A303 Stonehenge
Amesbury to Berwick Down
Report on Public Consultation

Appendix C

September 2017

Figure 1. Long barrows located around the upper west arm of the Stonehenge Bottom dry valley system. 1m contours and shaded topography from lidar survey.

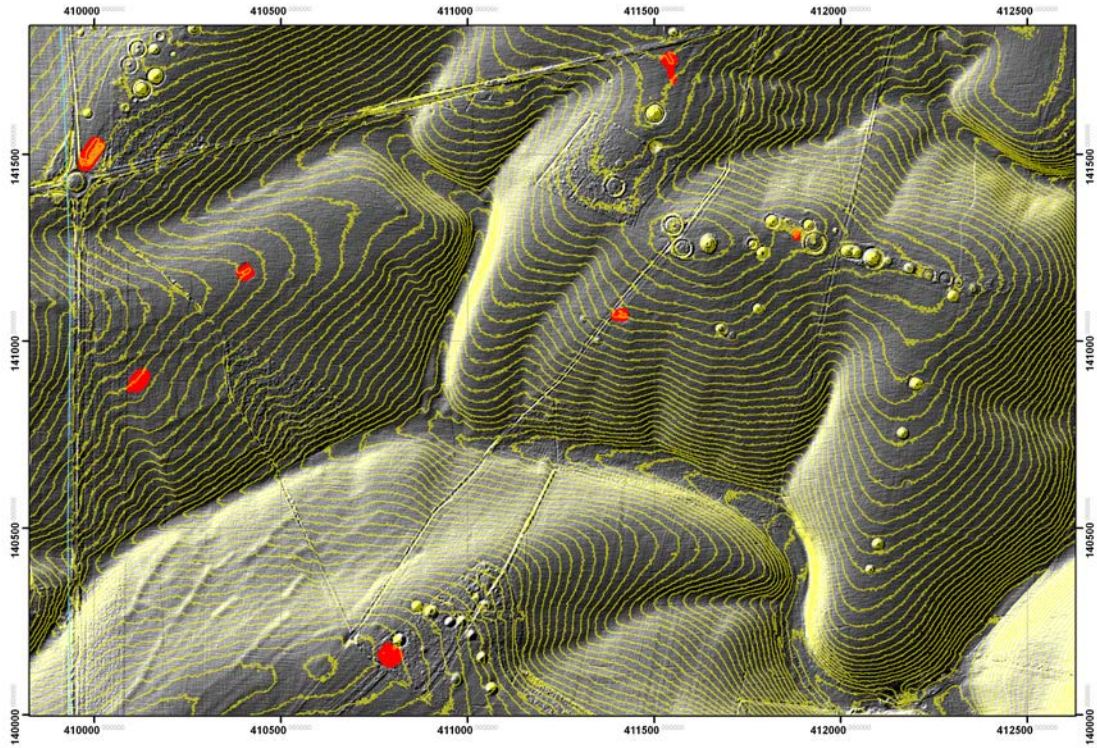
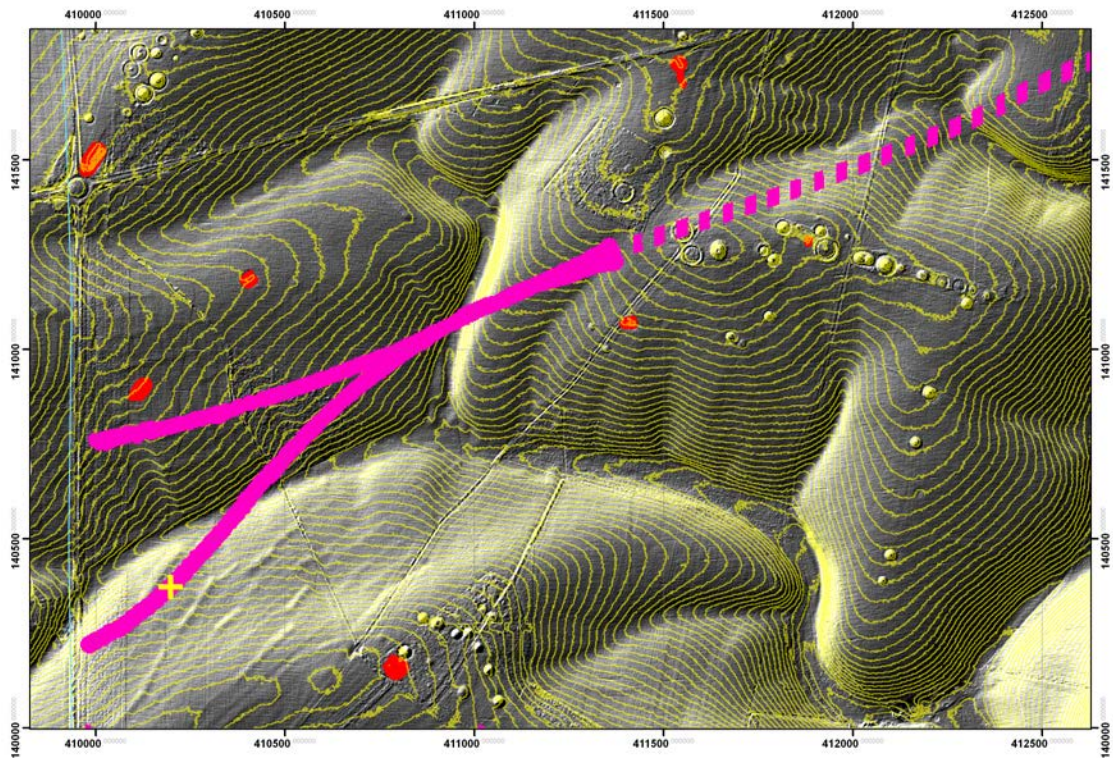
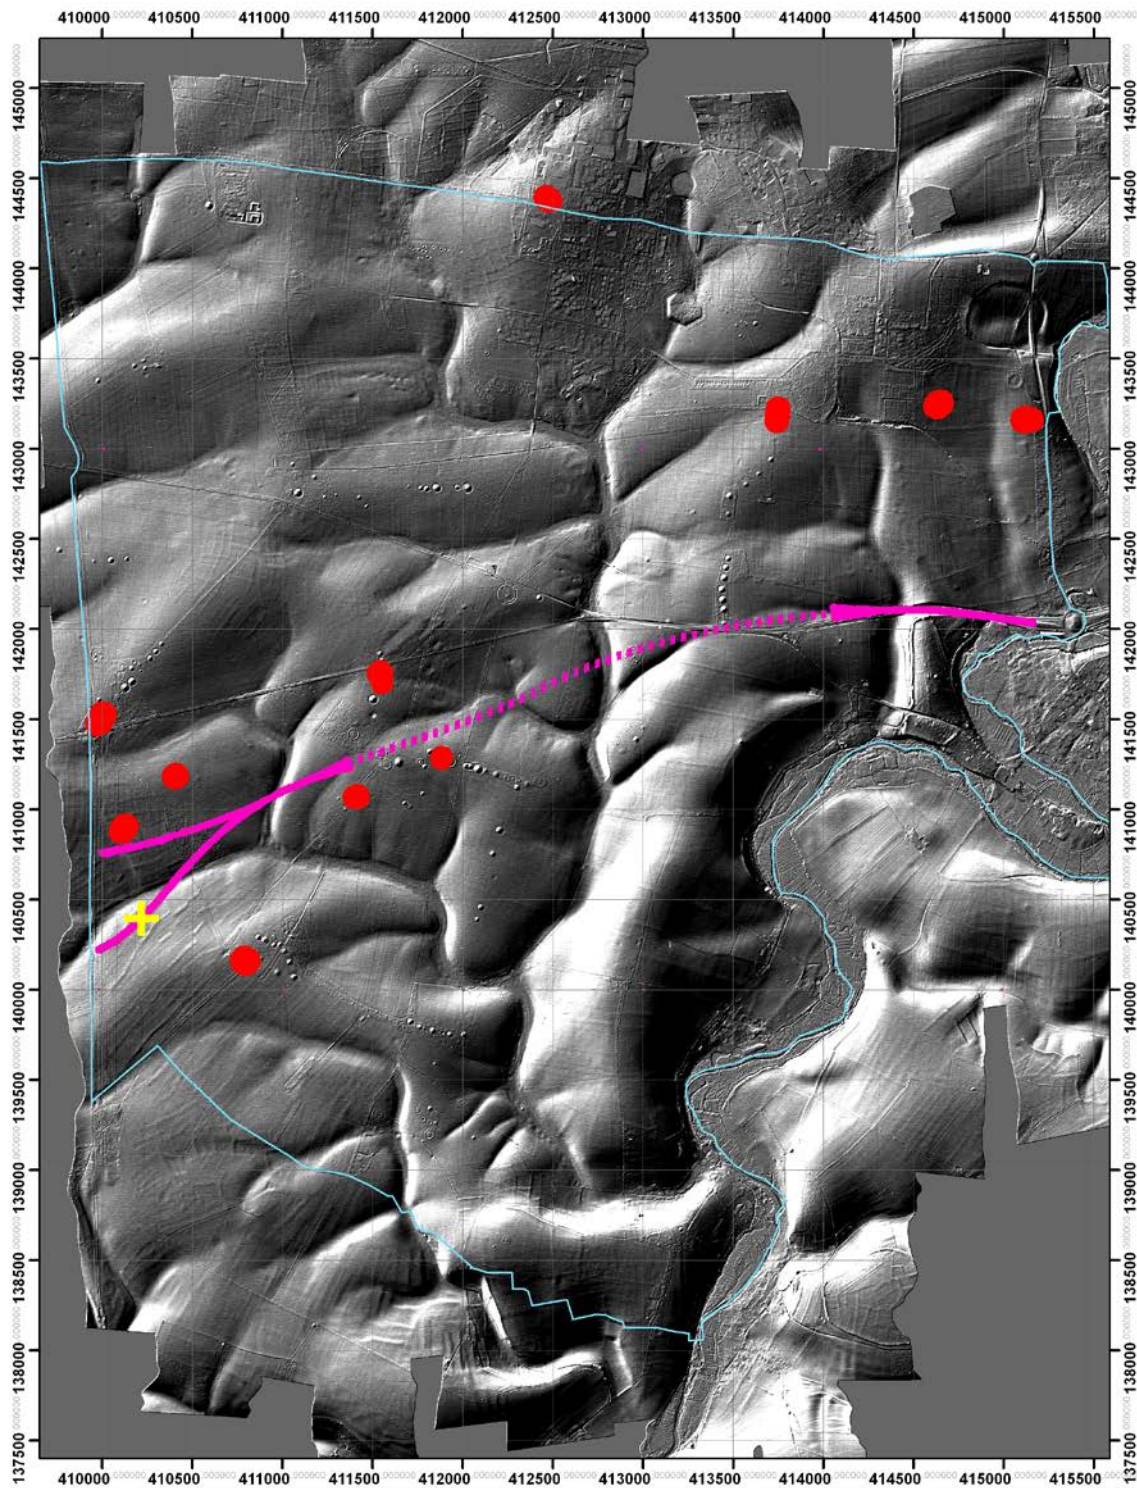
In landscape terms the western section of the road scheme, both the portal and the alternative westward dual carriageways, as given in the consultation plans, directly affects the, at present, undisturbed open landscape of the upper western arm of the Stonehenge Bottom dry valley system between Wilsford and Lake Downs. Located in this area are monuments, including the unique cluster of Neolithic Long Barrow and Mortuary sites, that appear to have been overlooked, or considered unimportant, in the Highways England evaluation of the route. This seems to be still also the case for the National Trust, English Heritage and Historic England, who in their recent press statement on the Scheme just seek adjustment of the western portal further away from the Normanton Down Barrow cemetery. As such this would appear to be a perpetuation of a 'Big Monuments' view, regretted at the recent ASHRG meeting, that takes less note of the less visible monuments and perpetuates the focus on the central site of Stonehenge and visibility therefrom, a focus considered inappropriate in the current Management Plan.

The grouping of the early Neolithic Long Barrow monuments, both long mounds and oval barrows, and their particular setting (Bewley, Crutchley and Shell 2005, *New Light on an Ancient Landscape*, Antiquity 79, p642) around the upper part of the western dry valley system, is unique in the WHS (Figure 1). The concentration of nine monuments (out of the twelve in the WHS), including the Mortuary Structure and a further long barrow revealed south of Winterbourne Stoke Cross Roads and west of Lake Long Barrow in the current evaluation (ArupAtkins ASHRG presentation), is clearly the dominant focus of early Neolithic human activity (3700-3000 BCE) in the WHS. Its density of monuments at 2 per sq.km, in less than 10% of the area of the WHS is unique both in its concentration and monument disposition. (Figures 1-3).

Figure 4. Association of EBA Round Barrows, outlined in blue, with Long Barrows.

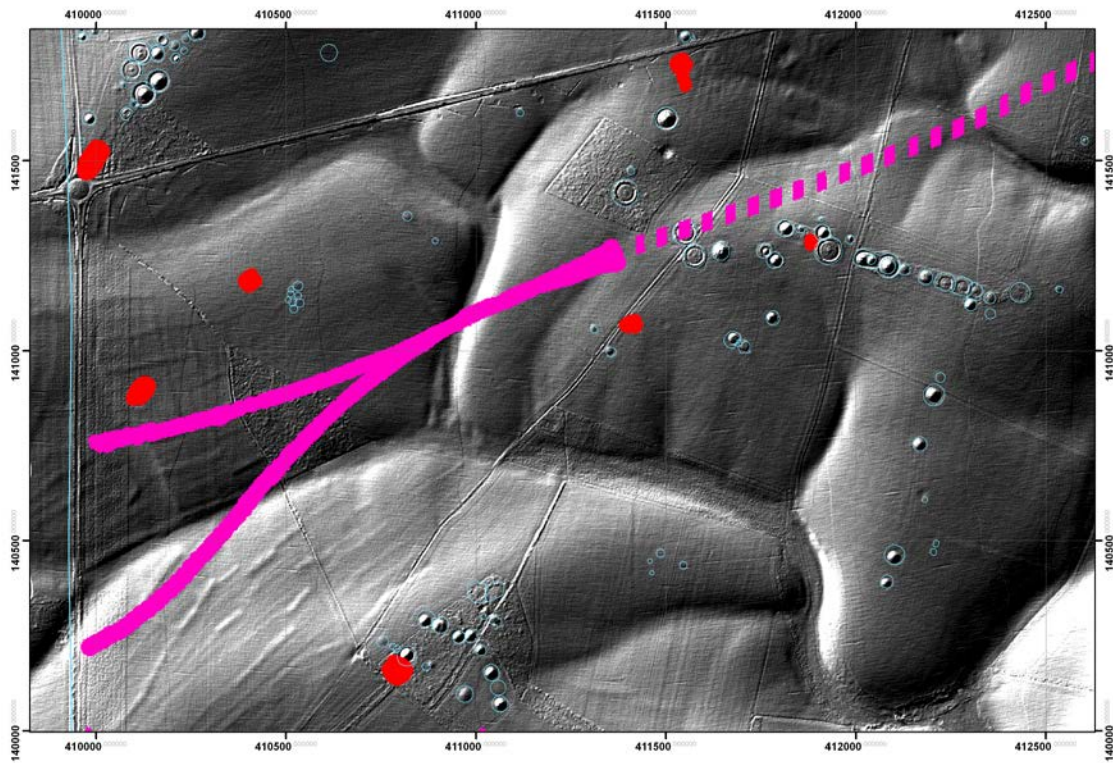
The early dating (3500 BCE) by Parker Pearson of bluestone quarrying and Cunnington's record of a bluestone being encountered in Boles Barrow on Salisbury Plain suggests the association of the people of these monuments with the first stage of the Stonehenge monument itself. The mounds retain their significance into the Early Bronze Age as an enduring focus for round barrow cemeteries, both the long linear 'display' cemeteries of Winterbourne Stoke and Normanton Down and the grouped burials of Lake and Wilsford 34 (Figure 4).

Figure 5. Bronze Age field system and linear boundaries from Historic England National Mapping Programme.

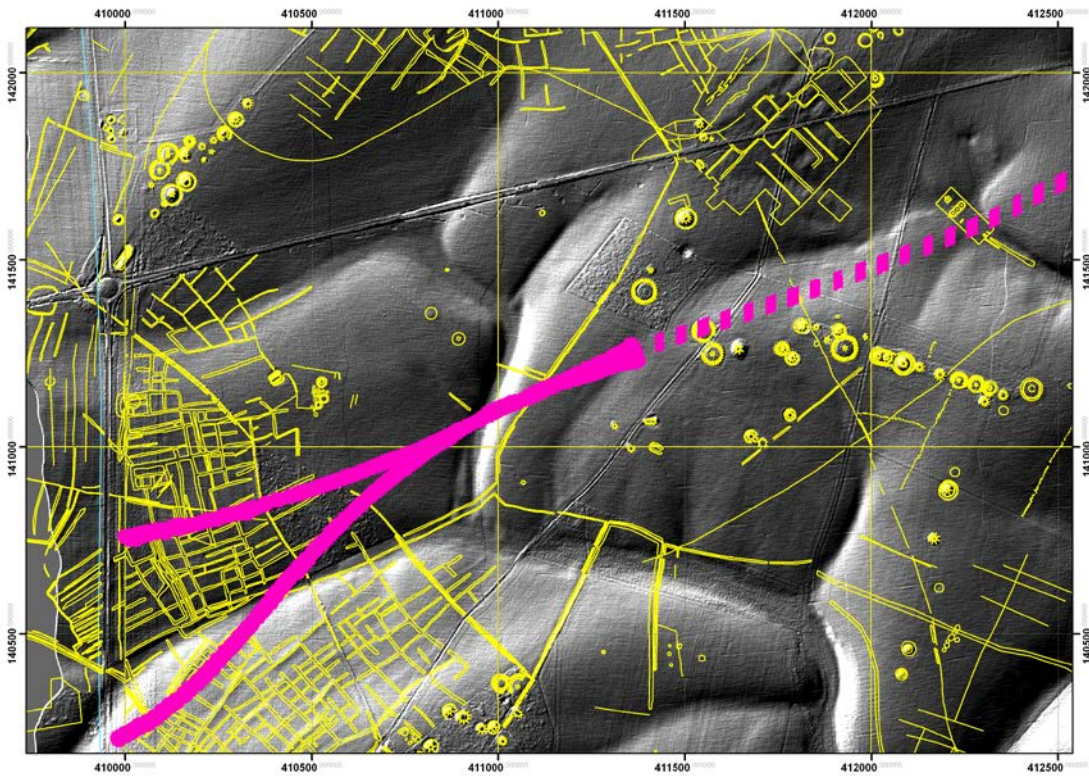
The presently proposed road cuts through the Bronze Age linear that runs SE from Long Barrow Cross Roads. This monument, which survives as an earthwork, can be seen to postdate much of an underlying Bronze Age field system (Figure 5). The field system itself survives as vestigial shallow topography, visible in the lidar survey (Bewley et al, above) and recent geophysics. An integral part of the field system is the droveway or trackway which proceeds north eastward along the dry valley bottom and expands to encompass a presumed grazing area on Normanton Down, "neatly bounded by linear ditches following the slopes of the dry valley," (Bowden et al. 2012. *Stonehenge World Heritage Site Landscape Project: Lake Barrows, The Diamond and Normanton Gorse*, HE Research Report 129-2012, p.30) that respects the Normanton Down Cemetery and more extensively the area around Stonehenge. Part of the western linear ditch survives as an earthwork in Normanton Gorse.

Figure 7. UNESCO WHS Inscription map of Stonehenge and Associated Monuments with Monuments outlined in red. (file UK-373-001-1.tif from http://whc.unesco.org/en/list/373/multiple=1&unique_number=1633)

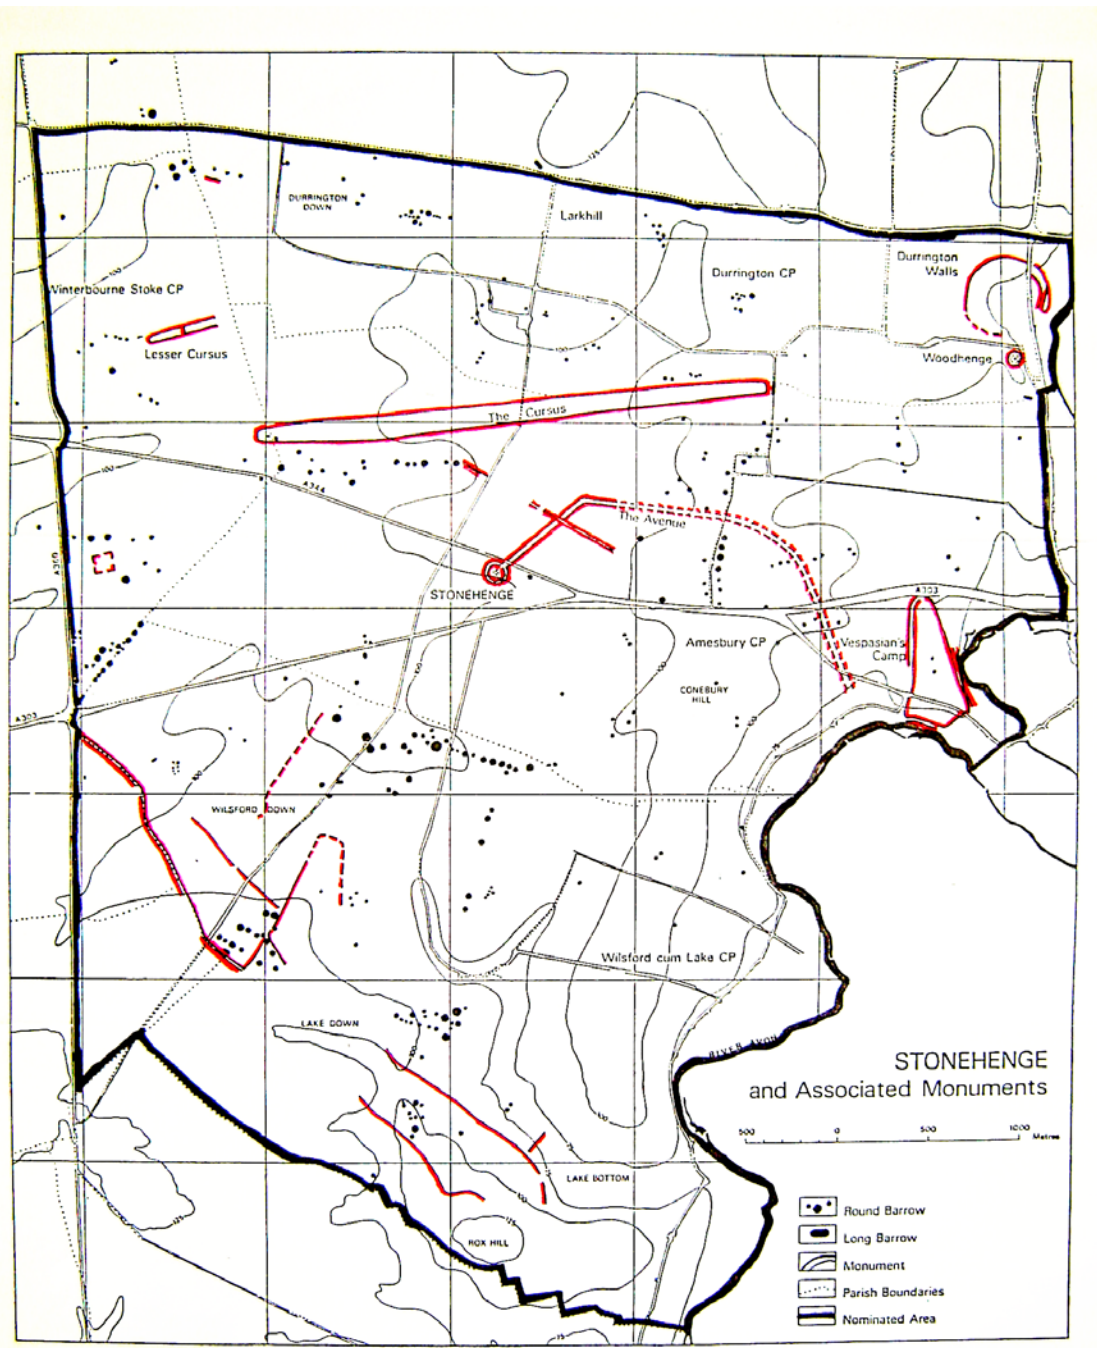
It is important to note that both the BA Linear and a long section of the western Droveway Linear are mapped as Associated Monuments in the UNESCO Inscription of the Stonehenge and Avebury and Associated Sites World Heritage Site (see Figure 7).
